WINTER SUBDIVISION

# PRELIMINARY OVERALL AREA DEVELOPMENT PLAN APPLICATION (POADP)

POADP # 454 - B

The City Staff Development Review Committee has reviewed Winter Subdivision Preliminary Overall Area Development Plan # 454 - B. Please find enclosed a signed copy for your files. Although your plan was accepted, please note the following:

P. O. A. D. P.

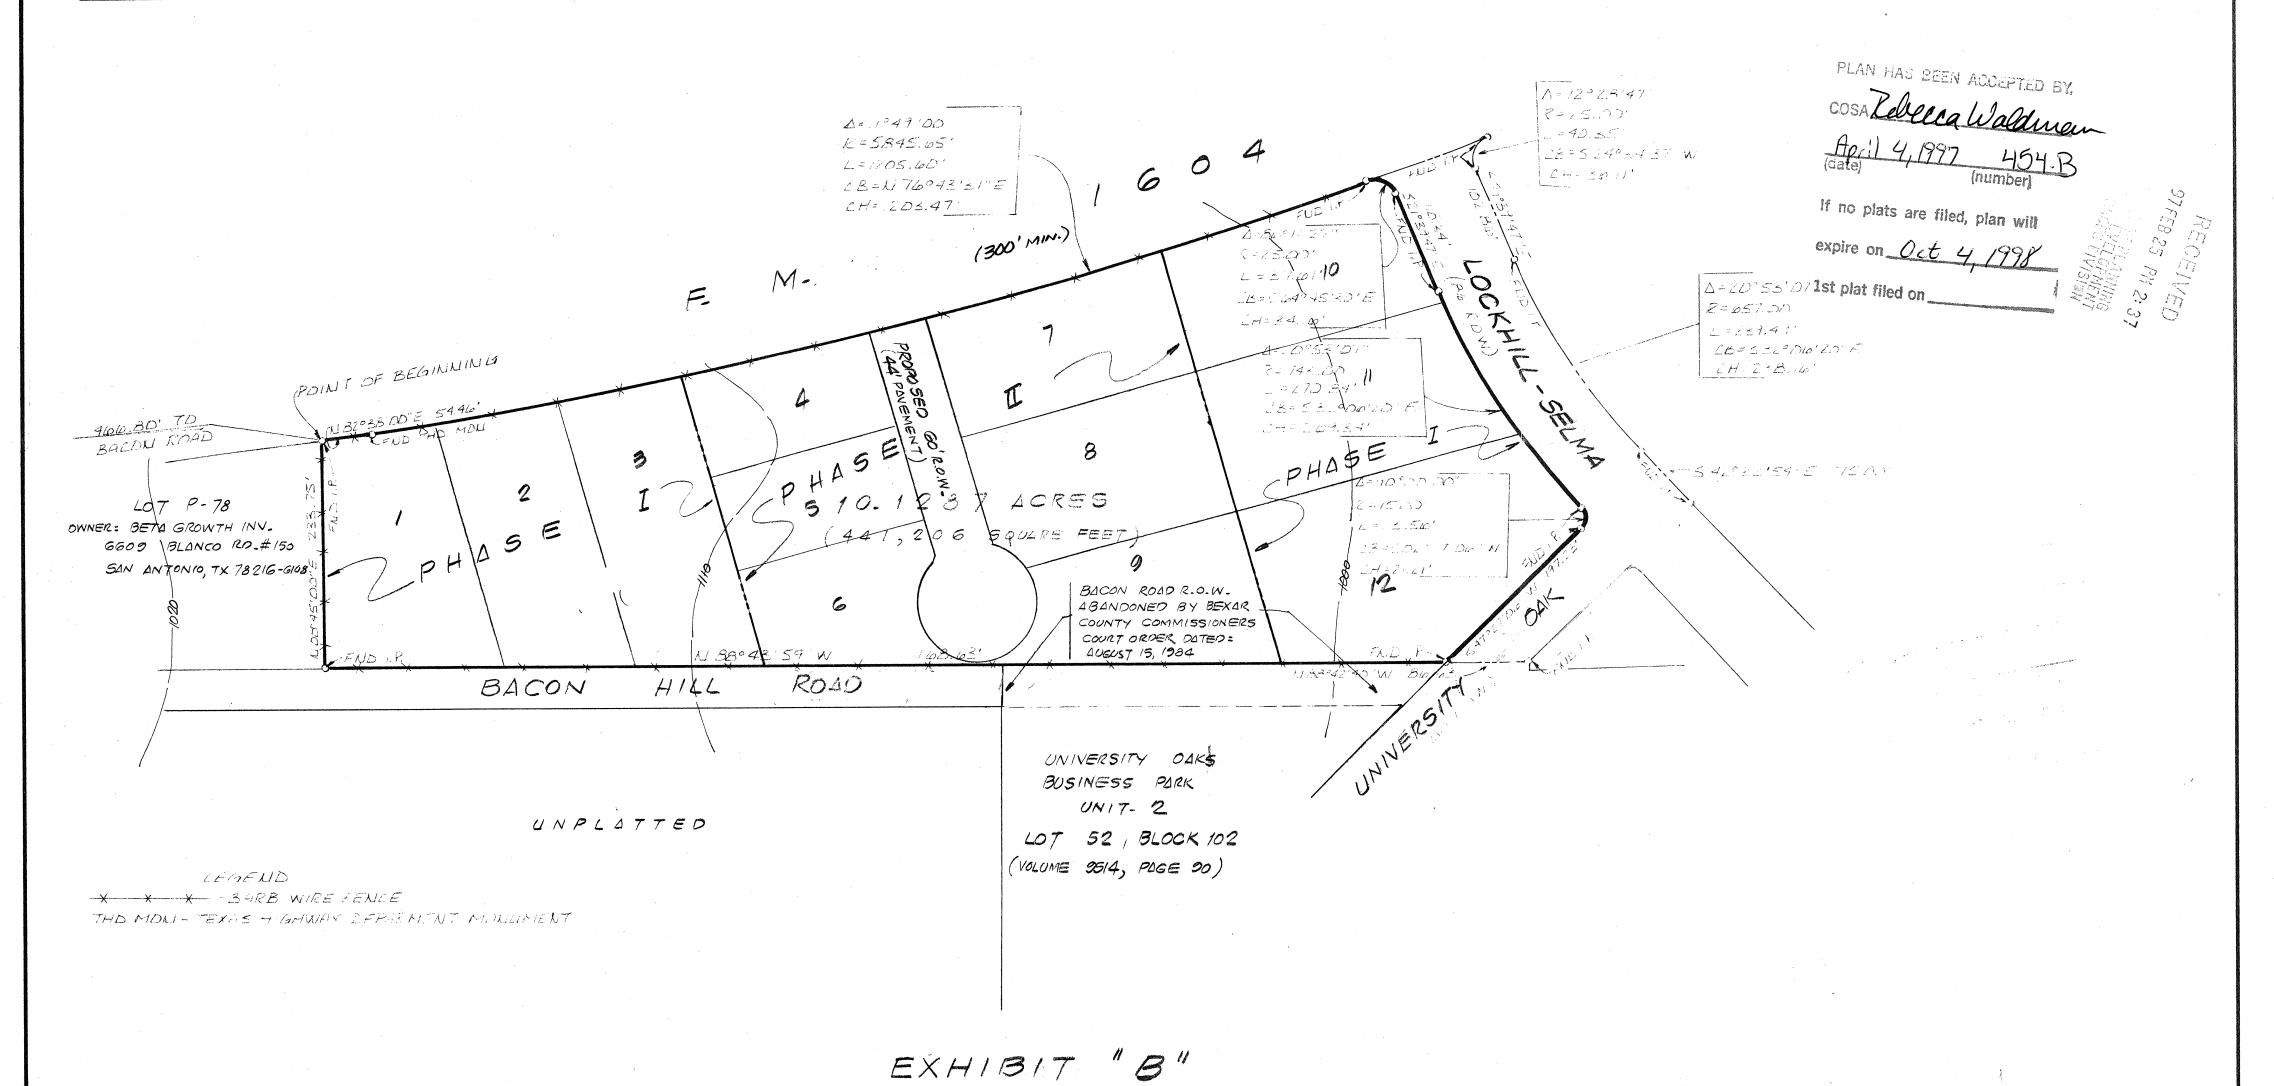
- Based on the topography, a Flood Plain Study and drainage review will probably be required during the platting process.
- Access and R.O.W. issues along State facilities will need to be resolved with the Texas Department of Transportation (TXDOT). For additional information about these requirements you can contact TXDOT at 615-5814.
